Company	Trenz Electronic GmbH
PCN Number	PCN-20260916
Title	TEM0007-01 to TEM0007-02 Hardware Revision Change
Subject	Hardware Revision Change
Issue Date	2026-09-22

This change affects all Trenz Electronic TEM0007 SoMs: TEM0007-01*.

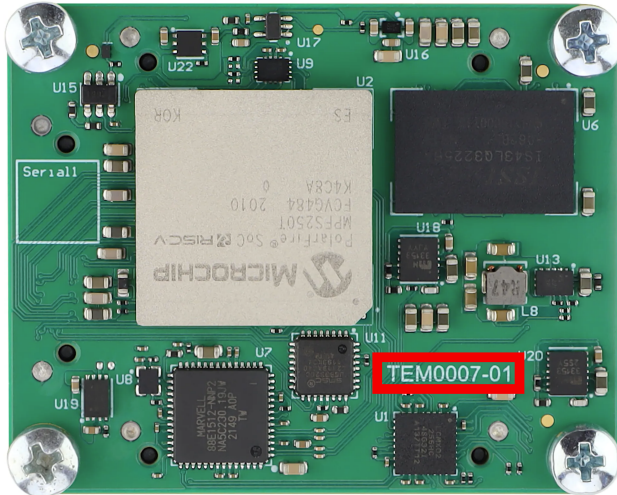
#13 Added RoHS and WEEE logo.

Type: PCB Change

Reason: Improve product classification identification.

Impact: None.
